# CITY PLAN COMMISSION STAFF REPORT

Bristol North Townhomes

CD-CPC-2024-00084

Development Plan - Residential

PRELIMINARY STREAM BUFFER PLAN

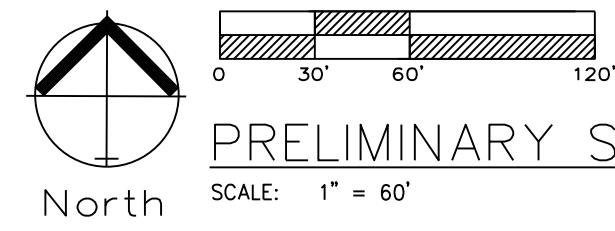
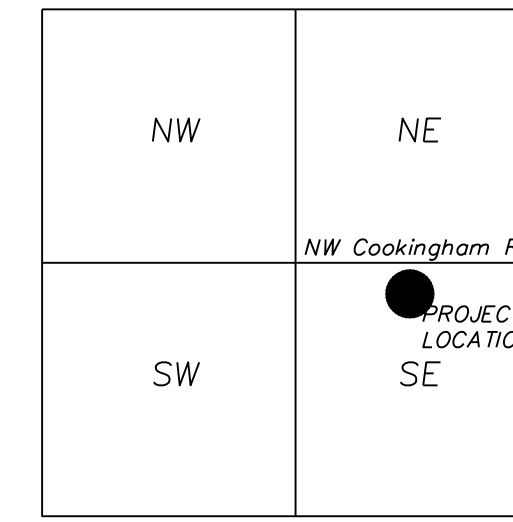
- Include the information from 88-415-07-D-2 on the preliminary stream buffer plan. Also include a stream buffer design table that shows the following: a. Area of each of the stream side and outer zones. b. Area disturbed within each of the zones (storm pipes constitute outer zone disturbance) c. Percent disturbed for each zone. d. Any areas of mitigation (if applicable).
